Reference: Hanford Waste Vitrification Plant
DOE Contract DE-AC06-86RL10838
Fluor Contract 8457

DESIGN CHANGE NOTICE

DCN - 0047

DCN TITLE
RE-ROUTING DIRECT
BURIAL CABLES

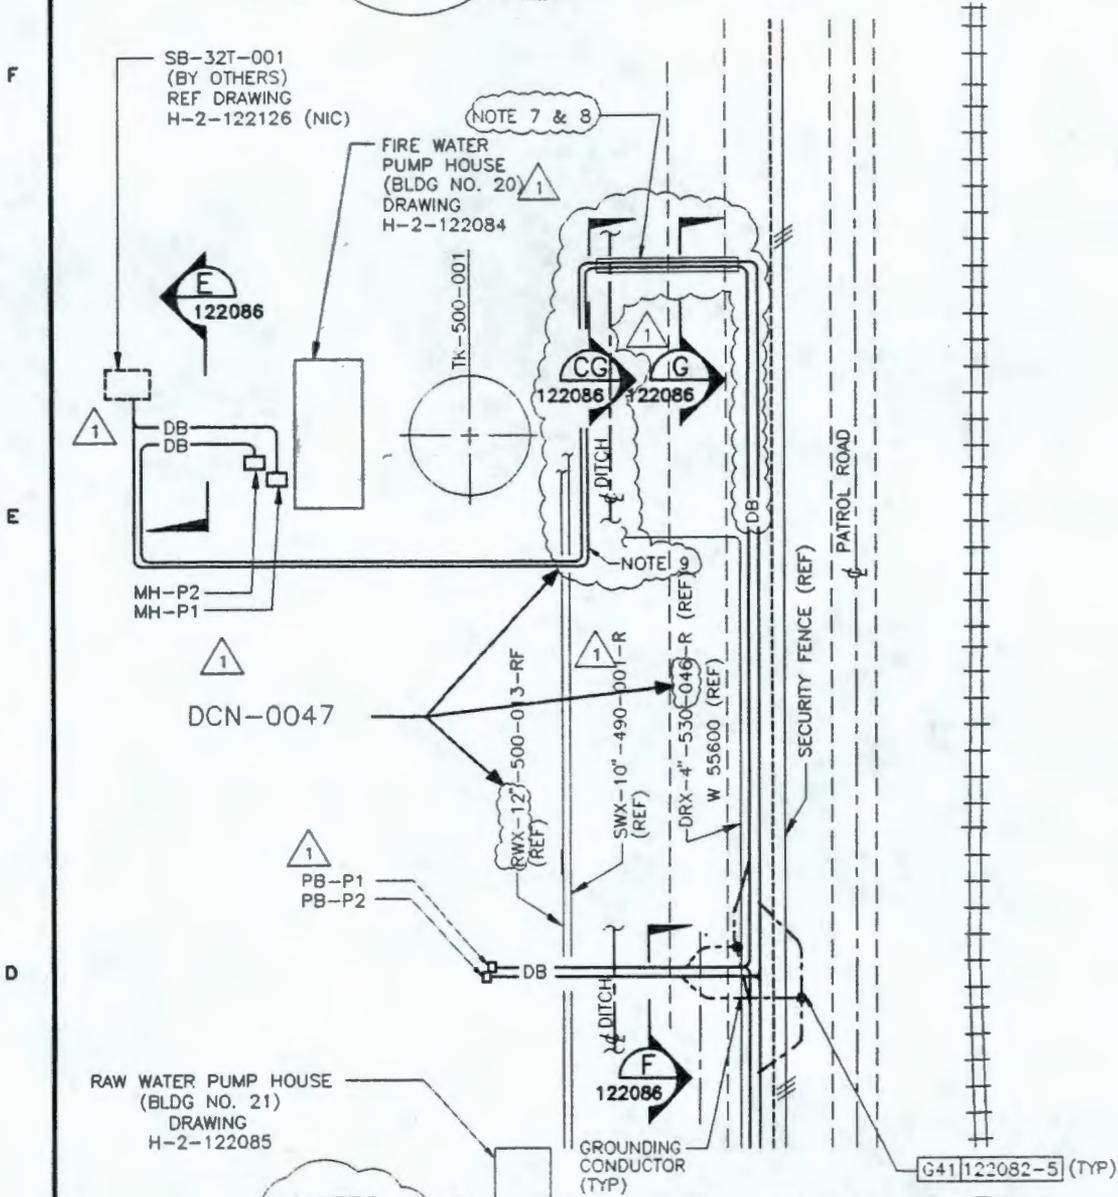
RE-ROUTED DIRECT BURIAL CABLES TO CONSOLIDATE WITH A170 DIRECT BURIAL CABLES UNDER DITCH. PROVIDED 6" SLEEVES FOR CABLES UNDER DITCH. ADDED SECTION "CG", "AJ" FOR CABLES UNDER DITCH. ADDED SECTION "HB" UNDER 7TH STREET CROSSING.

DOCUMENT NUMBER	SHT/PAGE	REV NO	DOCUMENT NAME	INCLD Y/N	DESCRIPTION OF CHANGE
H-2-122086	1	2	UNDERGROUND SECTIONS	Y	ADDED SECTIONS "CG", "AJ" AND "HB".
H-2-122093	1	2	UNDERGROUND CABLE PLAN	Y	PERROUTED CABLES ADDED SECTION CUTS AT DITCH AND 7TH STREET CROSSING.

7. FOR ADDITIONAL UNDERGROUND DIRECT BURIAL CABLE IN THIS AREA SEE REF DWG H-2-122126 SH 1. (NIC)
8. CENTERLINE OF EXISTING DITCH & ROAD CROSSING DUCT BANK IS APPROXIMATELY N 42880.
9. CENTERLINE OF TRENCH IS APPROXIMATELY W 55664.

SECTION **CG**
SCALE: NONE
122093

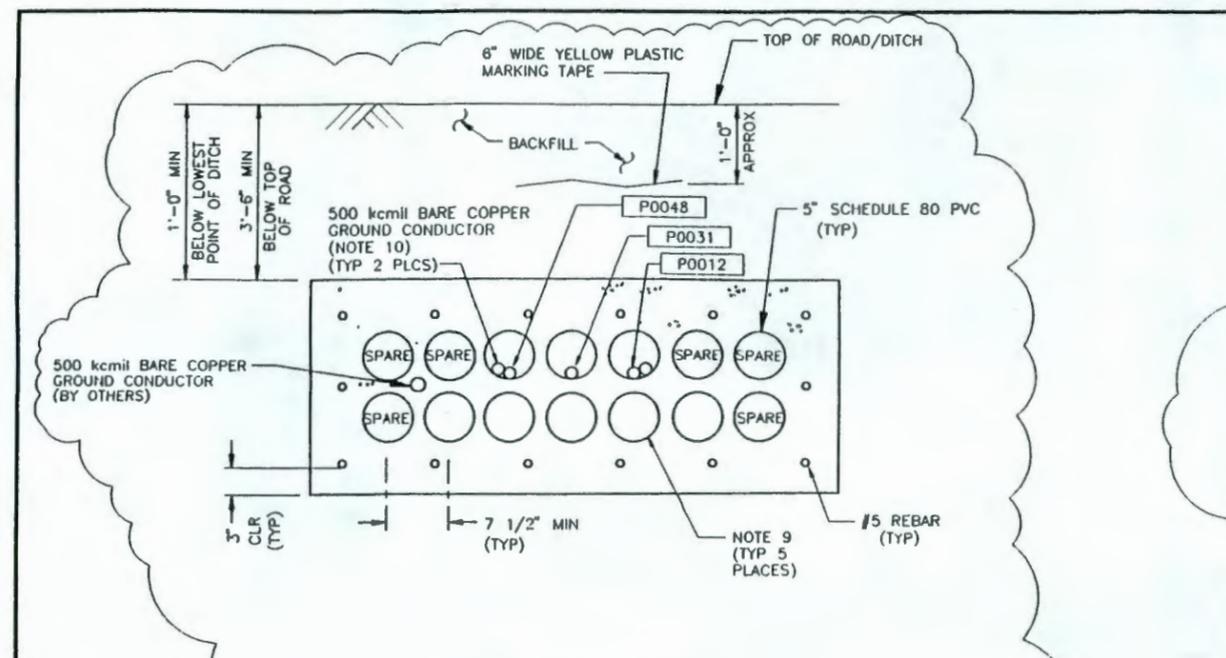
ROAD & DITCH CROSSING

- NOTES:**
- UNDERGROUND DITCH & ROAD CROSSING DUCT BANKS (CONDUIT SLEEVES) ARE EXISTING (BY OTHERS)
 - DIRECT BURIAL CABLES ARE EXISTING (BY OTHERS). EXTREME CAUTION SHALL BE TAKEN WHILE INSTALLING CABLES IN UNUSED CONDUIT SLEEVES.
 - DIRECT BURIAL CABLES P0012, P0016, P0018, P0020, P0022, P0025, P0027, P0031, P0048 & 500 kcmil BARE COPPER GROUND CONDUCTORS SHALL BE INSTALLED BY THE SELLER.

SECTION **AJ**
SCALE: NONE
122093

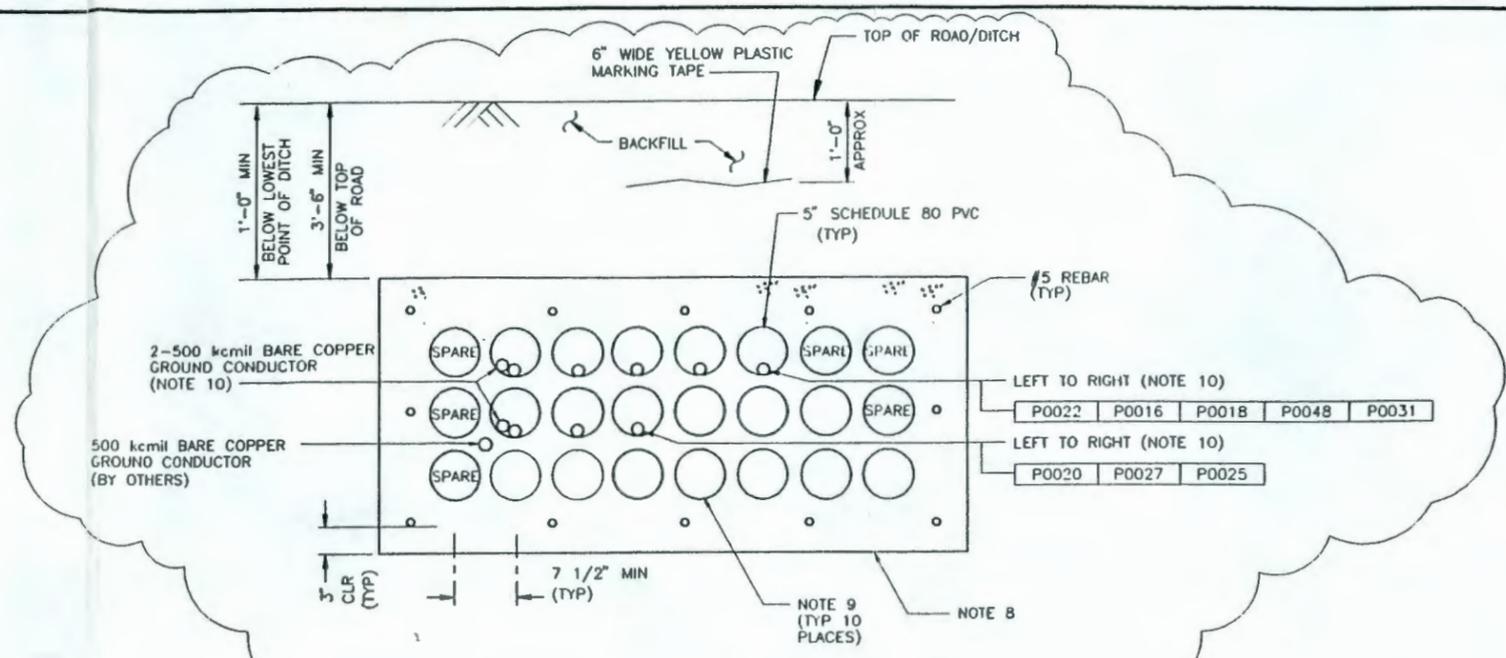
ROAD & DITCH CROSSING

SECTION **HB**
SCALE: NONE
122093

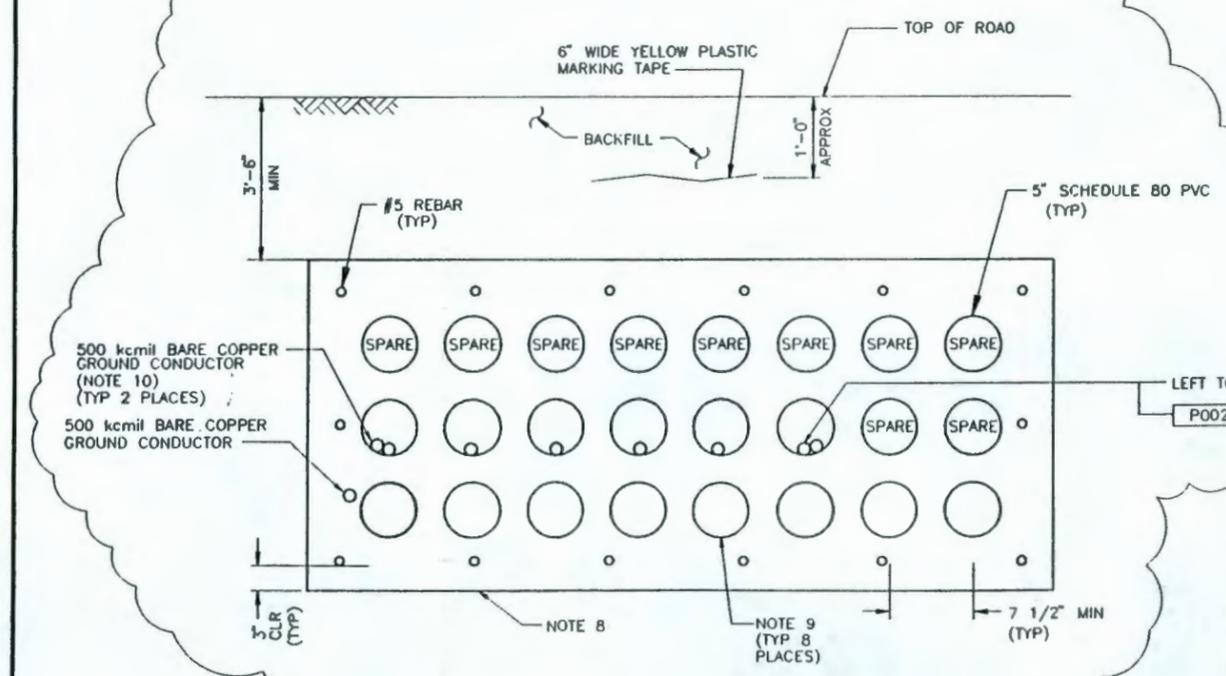
SEVENTH STREET CROSSING
